RE: Buckingham Compressor Station, Registration No. 21599

The Southern Environmental Law Center offers the following comments on the draft air permit for the Atlantic Coast Pipeline, LLC's ("Atlantic") proposed Buckingham Compressor Station, Registration Number 21599 ("Draft Permit"). These comments are submitted on behalf of the Southern Environmental Law Center, Friends of Buckingham, Natural Resources Defense Council, Sierra Club, Shenandoah Riverkeeper, Potomac Riverkeeper, Shenandoah Valley Battlefields Foundation, Virginia Wilderness Committee, Augusta County Alliance, Shenandoah Valley Network, Highlanders for Responsible Development, the Chesapeake Climate Action Network, Wild Virginia, the Allegheny-Blue Ridge Alliance, and Defenders of Wildlife.

The following technical comments were prepared by Vicki Stamper⁷¹ and pertain to the Virginia Department of Environmental Quality’s (VDEQ’s) proposed permit for Atlantic’s proposed Buckingham Compressor Station, Registration Number 21599.

Figure 1: Map of Households Surrounding the Proposed Buckingham Compressor Station

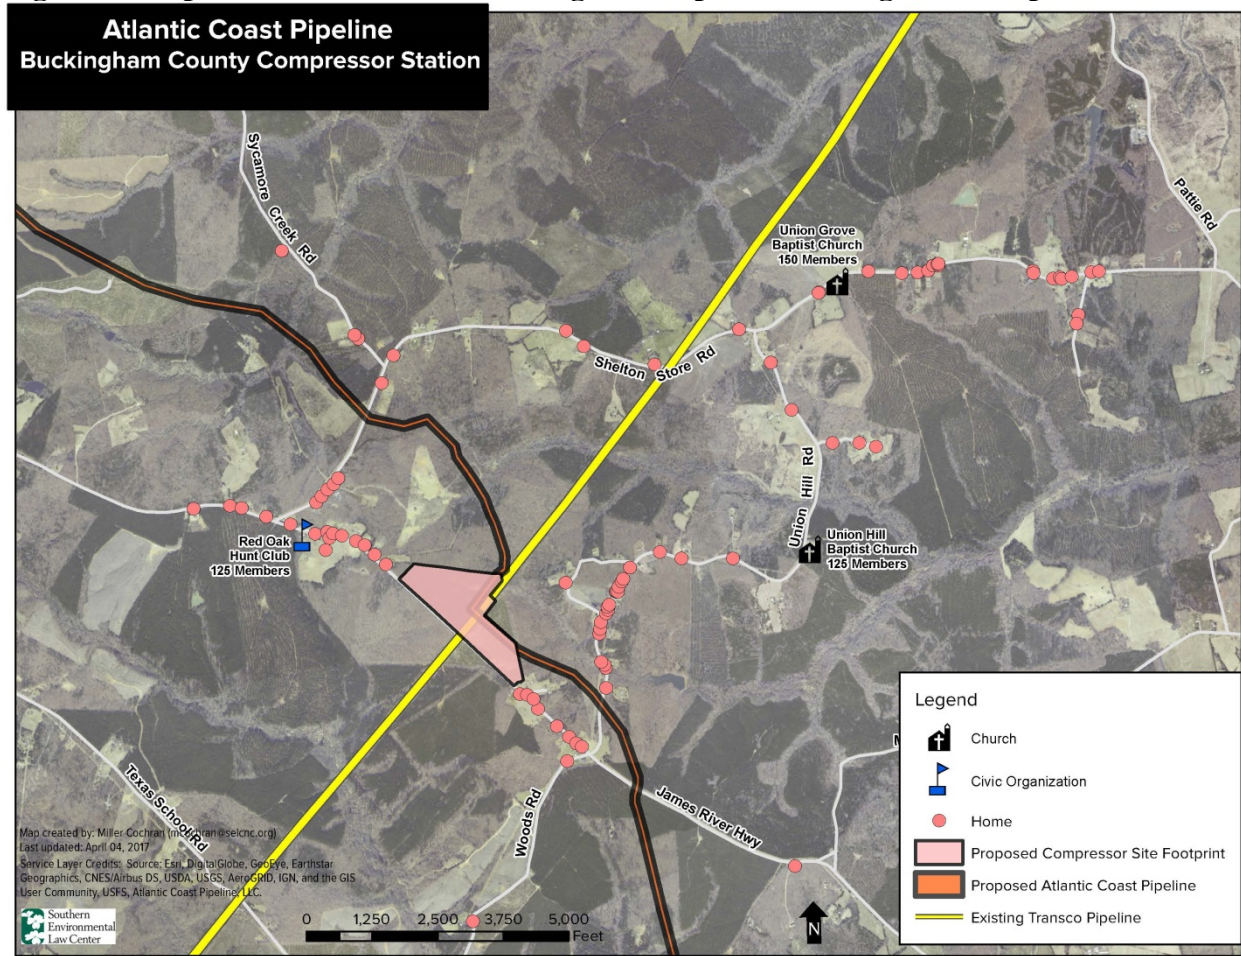
As part of its site suitability analysis, VDEQ determined that the area around the proposed Buckingham Compressor Station is “sparsely populated” and primarily surrounded by forests.⁵⁷ This conclusion is not consistent with the denser than average Union Hill community that inhabits the area within a one-mile radius of the site. To reach this flawed conclusion, it appears that VDEQ relied on Atlantic’s use of countywide population density data of 29.6 people per square mile.⁵⁸ But this county-level population density data does not reflect the actual characteristics of the neighboring community. As noted above, Friends of Buckingham has identified nearly 100 households in the 1.1 mile radius of the proposed compressor stations. The 75 households surveyed to date are made up of 199 residents.

As seen in Figure 1 below, there are significant clusters of households in the area surrounding the proposed compressor station:

This disparity is significant, and the large number of households that in fact lie close to the proposed compressor station contradict VDEQ’s site suitability conclusion that the area around the Buckingham compressor station is primarily surrounded by forests and sparsely populated. The Air Board must independently consider the unsuitability of this proposed location for a new source of industrial air pollution.
